PROJECTILE, 76MM/62 CALIBER, MK -- FROM AISI 9260 STEEL

FINAL REPORT

Contract N00178-74-C-0030

PUBLISHED BY DIRECTION OF  
NAVAL WEAPONS LABORATORY

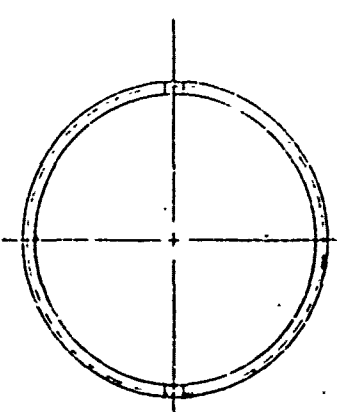
Heat treating is a problem because the drawing specifies both mechanical properties and a hardness range. The two are not necessarily compatible, and one or the other should be eliminated from the drawing. Chamberlain Research and Development Division personnel prefer to work to a range of mechanical properties, with hardness as advisory only. Furthermore, for this item, the hardness range could be expanded to Rockwell "C" 26 to 36.

At the lower range, nose threads could be rapped rather than single point threaded. We realize that fragmentation characteristics may enter into consideration, and on that basis we do not make this a firm recommendation. However, the indication on the drawing should be to heat treat to either the mechanical properties or the hardness range.

Band seat machining proved troublesome because a special, rather expensive form tool had to be procured and there was a long elapsed lead time prior to receipt of the tool. The dovetail band seat undercut was split off from the grooving operation only because of equipment limitations at the time these projectiles were produced. Given larger quantities, Company engineers would rather add the undercut in the same chucking as groove cutting. The rather high ribs in the band seat were especially troublesome to knurl with standard shell knurling equipment and tooling. The O.D. of several setup bodies collapsed from tool pressure imposed by the rollers when the operator attempted to get a completely defined knurl to the bottom of each rib. A completely defined knurl was attained by knurling only 50% of the seat in a single pass. In this manner, pressure was reduced, but the operation took twice as long. The two-pass knurl met the print.

There was some divergent interpretation of the 1.850-.100 length for the nose thread. Company process engineers interpreted this as perfect thread length. Navy Quality Assurance personnel interpreted that the thread must proceed through the nose bore and tail off in the HE cavity. In order to do the latter, it was necessary to insert a hospital backbore operation

to trim excess material behind the thread. This was necessary because the existing Cri-Dan B single point thread lathe does not have sufficient stroke to pass through the entire nose area using the cam presently installed on the machine.

- 5.1       Revise the drawings to eliminate the hardness requirement, and stipulate that bodies should be heat treated to a range of mechanical properties, or vice-versa, whichever is more compatible with ballistic performance. If mechanical properties are stipulated, hardness should be advisory.

- 5.2       To ease manufacturing and tooling costs, the band seat configuration should be revised to a standard United States seat.
- 5.3       Clarify on the drawings that the nose thread should go all the way through to preclude ambivalent interpretations.

MANUFACTURING'S FLOW DIAGRAM

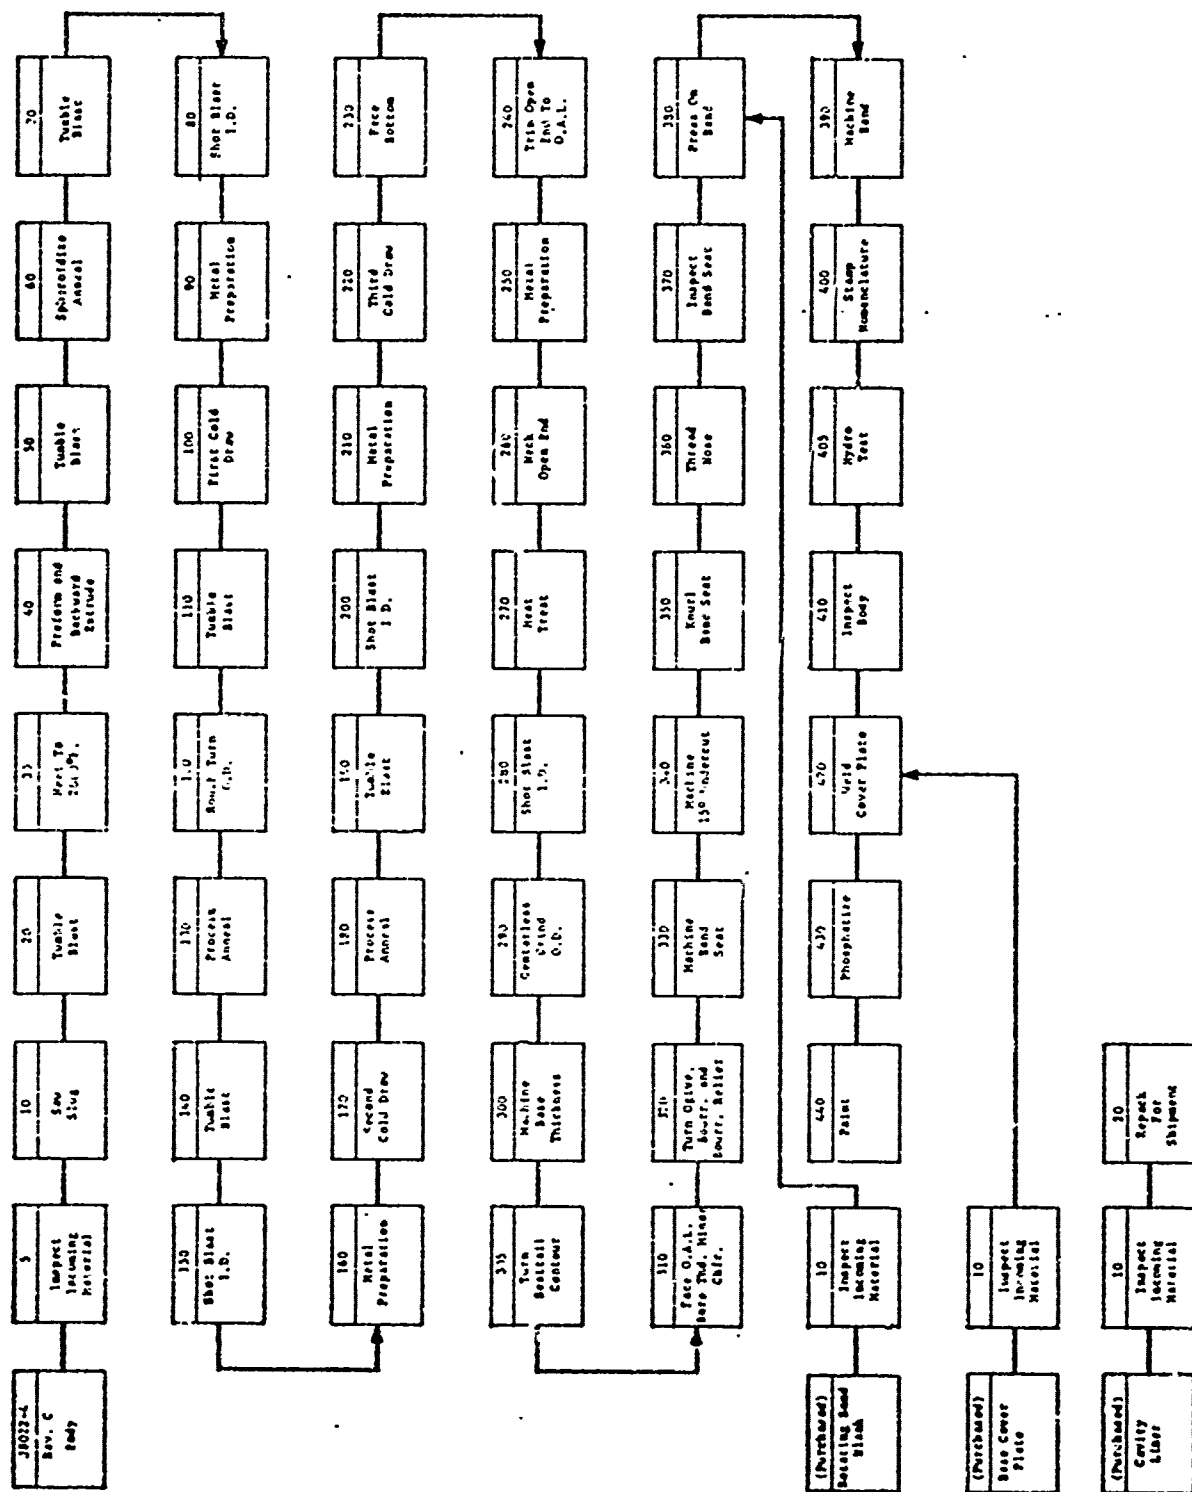
2.2 During all cold drawing operations there were about 3.5% rejects for cracked cans. Examination of the cracks revealed in each instance a stringer or inclusion in the material as shown by Photograph 10226 on the following page. In a mass production situation this reject rate would be prohibitive, meaning that extra precautions will have to be exercised over material. The problem would not apply as readily to a hot forge-hot draw process -- only to a cold draw process such as used during the program.

- 5.5       Consider investigation of the hot forge-hot draw process as a means of overcoming cracking induced by material inclusions. Otherwise, specifications for 9260 steel will have to be rather restrictive -- a situation which would increase the production cost of the projectile.
